CITY OF ALBANY
Alameda County, California

SPOKANE AVENUE/PORTLAND AVENUE SEWER IMPROVEMENT PROJECT 2012
CONTRACT No. C12-5

ADDENDUM NO. 1 - May 1, 2012

ADDENDUM # 1
BOX CULVERT/SEWER INTERFACE
PIPE BURSTING AND CULVERT REPAIR

STORM DRAIN BOX CULVERT/10 SEWER INTERFACE

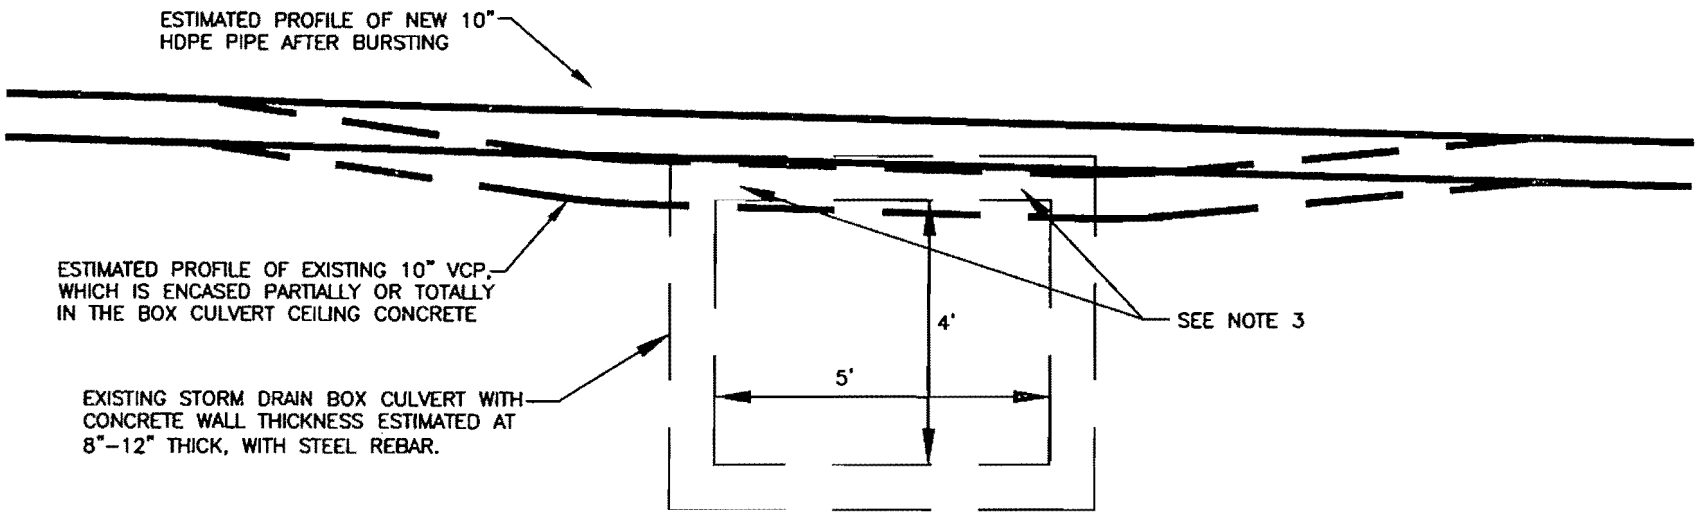
4. The attached 8 ½ " x 11"Detail drawing entitled "Addendum #1, Box Culvert/Sewer Interface, pipe bursting and culvert repair" shall be used to assist the proper pipe bursting of the 10" VCP to 10 HDPE pipe and repair of the box culvert. The bid amount for bid item 18 on the new bid schedule shall include all work as shown on this new detail plan sheet.

1. OPEN CUT EXCAVATE UP TO 25 LF OF SEWER TRENCH FROM MH 10-102-26 DOWNSTREAM TO JUST BELOW THE PIPE BOTTOM PER BID ITEM 16 ON THE CONTRACT PROPOSAL.

2. THE CONTRACTOR SHALL PROVIDE BYPASS PUMPING DURING THE CONSTRUCTION OF THIS SECTION OF PIPE. SANITARY SEWER CONTAMINATION OF ANY AMOUNT WILL NOT BE PERMITTED TO ENTER THE STORM DRAIN BOX CULVERT. THIS WORK WILL NOT BE PERMITTED TO MOVE FORWARD UNTIL THE ENGINEER CONFIRMS THAT BYPASS PUMPING IS IN PLACE. SEWAGE MUST ALSO BE DRAINED/PUMPED OUT OF THE PIPE SAG.

3. CONTRACTOR SHALL CAREFULLY CHIP AWAY THE BOX CULVERT CONCRETE SURROUNDING THE PIPE TO THE EXTENT THAT PIPE BURSTING CAN BE ACCOMPLISHED WITHOUT FURTHER DAMAGE TO THE BOX CULVERT.

4. WHEN PIPE BURSTING WORK IS COMPLETE, THE CONTRACTOR SHALL REPAIR THE BOX CULVERT. DRILL #4 REBAR DOWEL AT 12" SPACING, PENETRATING EXISTING CONCRETE 6". REBAR SHALL BE PLACED IN CEILING AND WALLS AT NO LESS THAN 12" SPACING AND A LENGTH EQUAL TO THE WIDTH OF THE CONCRETE REPAIR. FORMS CAN BE PLACED INSIDE THE BOX CULVERT TO SUPPORT THE CEILING AND WALL CONCRETE POUR. ACCESS TO THE BOX CULVERT IS AVAILABLE IN AN ADJACENT MANHOLE APPROXIMATELY 15 FEET FROM THE REPAIR LOCATION.
